AGENDA
**HISTORIC PRESERVATION/
DESIGN REVIEW COMMISSION**

Date and Time: December 2, 2021
5:00 PM

Design Review
1040 Main Street
December 2, 2021

PROPOSED ELEVATIONS

1 SOUTH (FRONT) ELEVATION
SCALE: 1/4" = 1'-0"

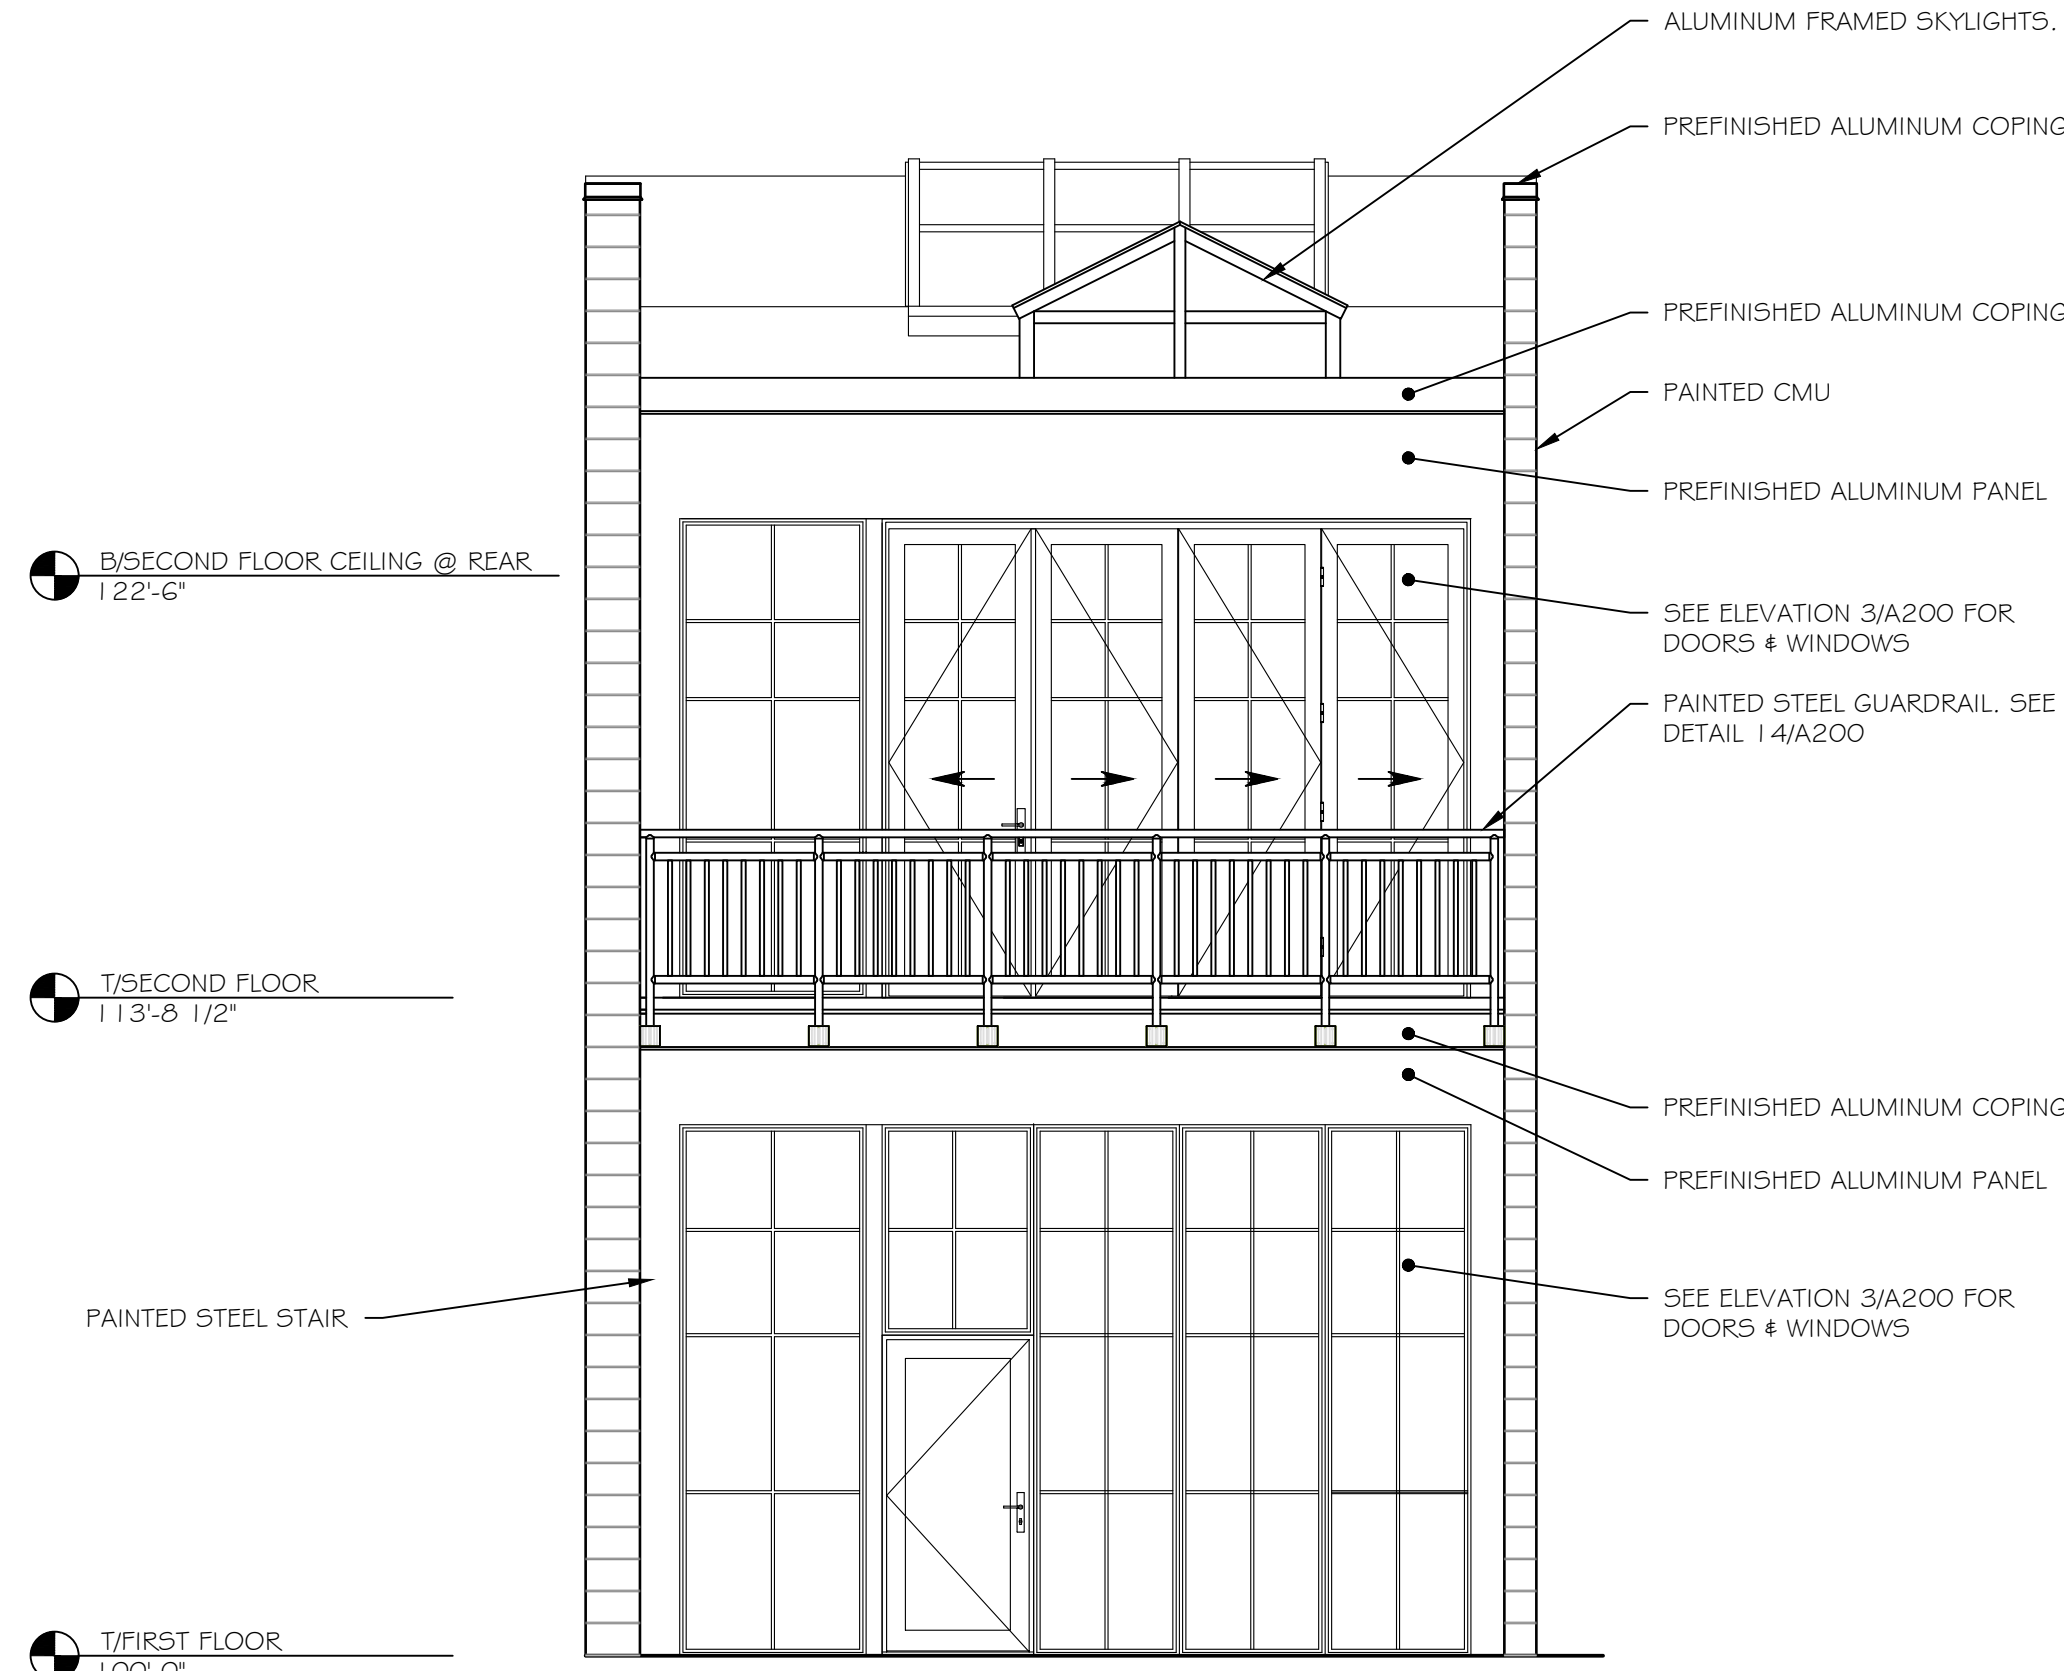
Analysis: New window and door openings are proposed on the south-facing wall of the historic structure.

Analysis: The 1908 photograph above shows that the current design of the storefront is different from what exists currently. This photograph is supported by the fact that the Wisconsin Historical Society states that the building's storefront is not representative of its original design.

Analysis: The one storefront door that exists off of Main Street is located in a different location than where the two proposed doors would be located.

Findings: The proposed doors and windows would be of the same size and include matching frames and muntin patterns.

Findings: The applicant's proposed storefront design would be recreated based off of its original design. Staff believes that the proposed design elements meet the original design provided that the conditions applied to this request are applied.

Findings: In recreating the original storefront design of the building, altering the storefront entrance is required. Since this is a restorative action to recreate the original design of the storefront, staff believes that this standard is met.

2 NORTH (REAR) ELEVATION
SCALE: 1/4" = 1'-0"

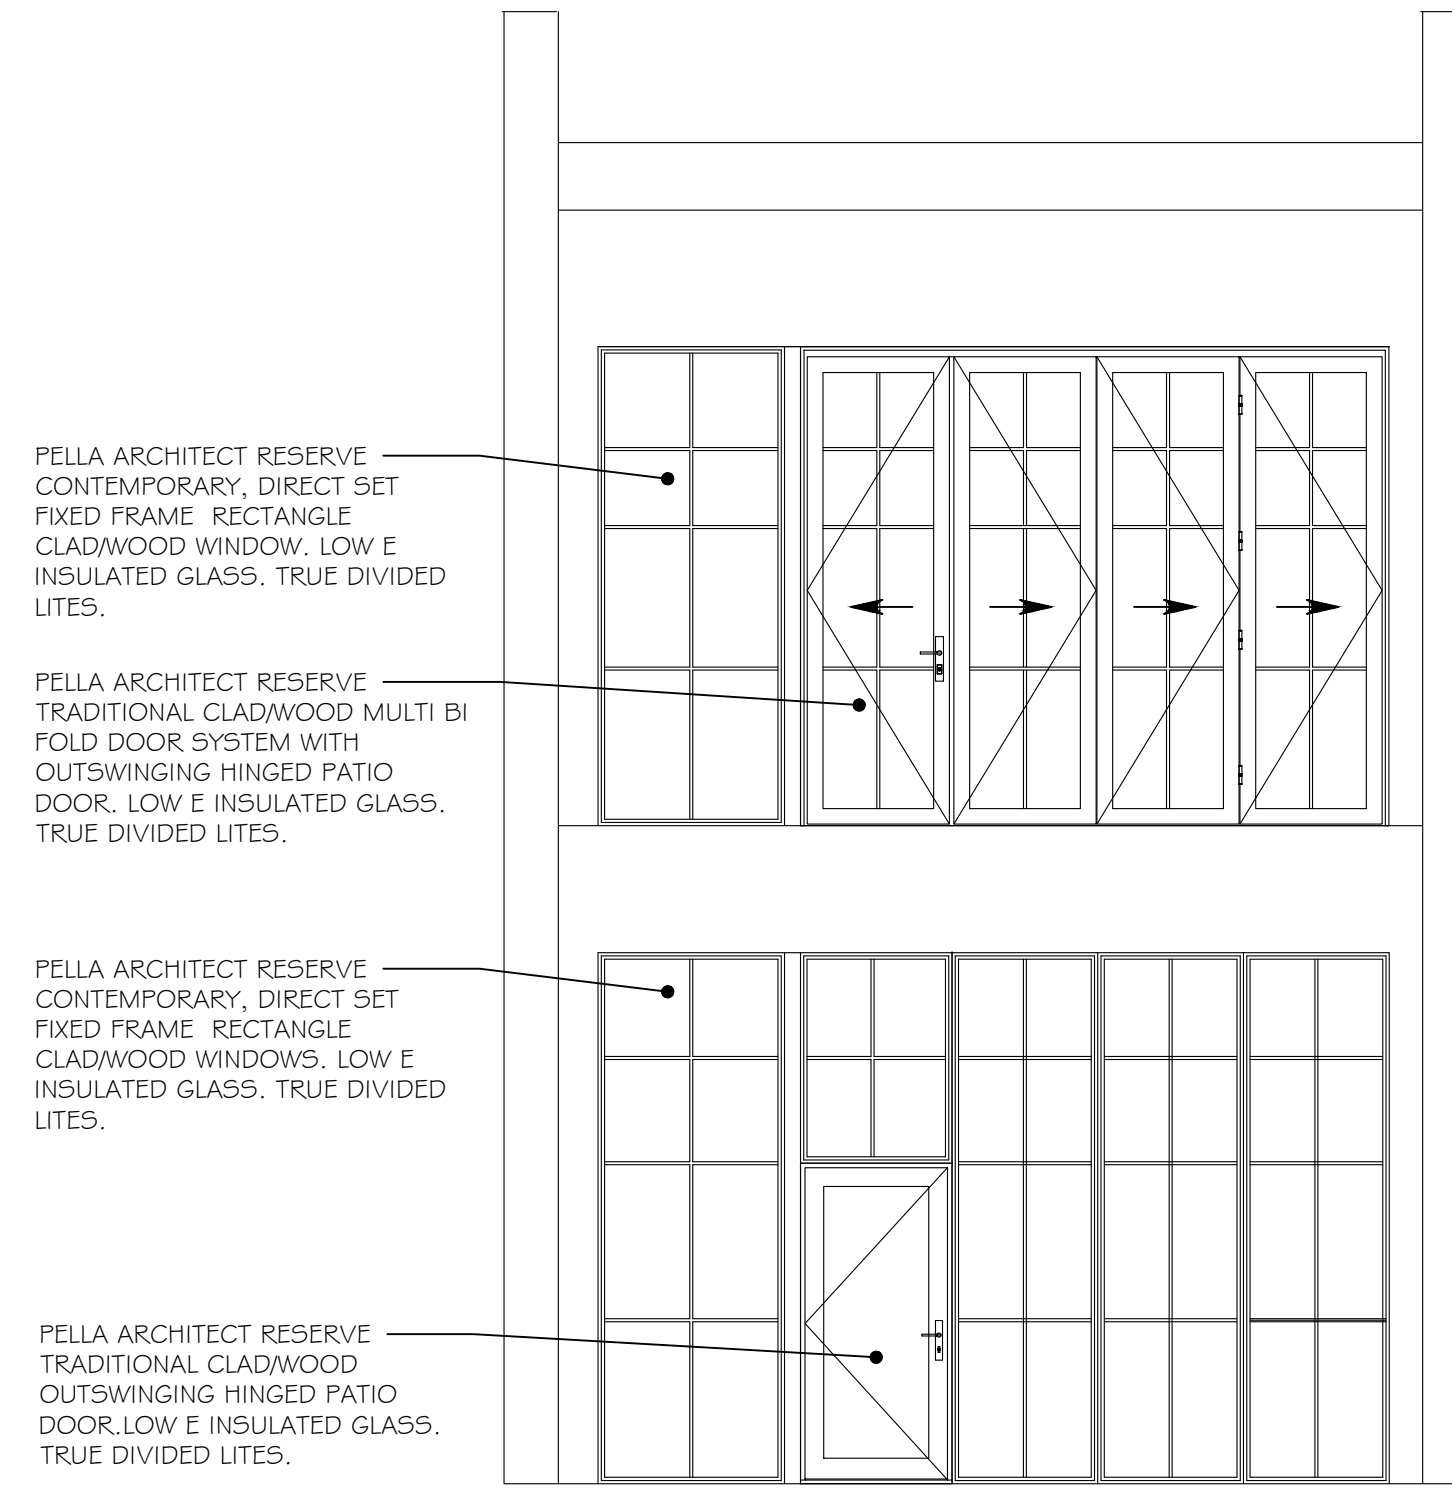
Analysis: The proposed addition would be located on the rear of the building. The rear of the property is visible by way of a public parking lot owned by the City's Redevelopment Authority.

Analysis: The north-facing wall consists of brick that is painted differently from the south-facing wall and is of a different pattern. One service door exists on the first floor to provide rear access into the building.

Analysis: The proposed building materials for the north-facing wall (i.e., brick, glass, aluminum and wood) would be consistent with the building materials that currently exist on the south-facing wall.

Analysis: As stated above, key elements of Italianate architecture are tall storefront windows. Gardens associated with Italianate architecture is consistent with having a more symmetrical garden, filled with landscaping and fixed objects (e.g., seating, statues, etc.). Additionally, most gardens were encapsulated with hedging or fencing to enclose the area.

Analysis: While the proposed addition complements the existing building, there are clear differences that differentiate the addition from the historic structure. For example, both stories of windows on the rear wall is of a different size as the storefront windows off of Main Street. Likewise, the muntin pattern as proposed for the window off of Main Street is different for the proposed rear wall. Additionally, while masonry is part of the building materials that is proposed for the addition, the rear wall uses a greater proportion of glass and aluminum. To the contrary, the front-facing wall off of Main Street consists primarily of glass, masonry and to a lesser extent wood trim.

Analysis: With different building materials taking greater prominence on the proposed rear wall, staff believes that this element along will show that it is clearly identifiable as being new.

Findings: The proposed addition would not alter the character-defining features located on the front-facing wall of the building (off of Main Street). While the proposed addition is visible to the public, it is important to note that the parking lot behind the subject property is not public right-of-way and is owned by the City's Redevelopment Authority for parking. Additionally, with landscaping planned create a public garden in the rear of the property, staff believes that these landscaping elements will assist in minimizing the visual impacts of the addition.

Findings: Customary with other historic buildings along Main Street, the rear of the building generally has significantly less character-defining architectural features as what the storefront wall. With the restorative actions that are planned by the applicant, staff believes that the proposed design would add architectural design and better complement the front-facing wall of the structure.

Findings: In reviewing the design request, it is important that the proposed addition complements, but not overpower, the existing

building. While more storefront windows are planned for the rear of the structure, there are other architectural amenities that exist solely for the front-facing wall (e.g., cornices, projecting eaves and the awning). Therefore, staff believes that the proposed addition would not overpower the existing make and configuration of the historic structure.

Findings: Based on the design elements proposed by the applicant, staff believes that the rear wall complements Italianate architecture common with buildings of the late 1800s. For the proposed garden, six-foot high galvanized picket fencing is proposed to enclose the garden from the adjacent sidewalk.

Findings: Staff believes that this standard is met.

Findings: Staff believes that this standard is met.
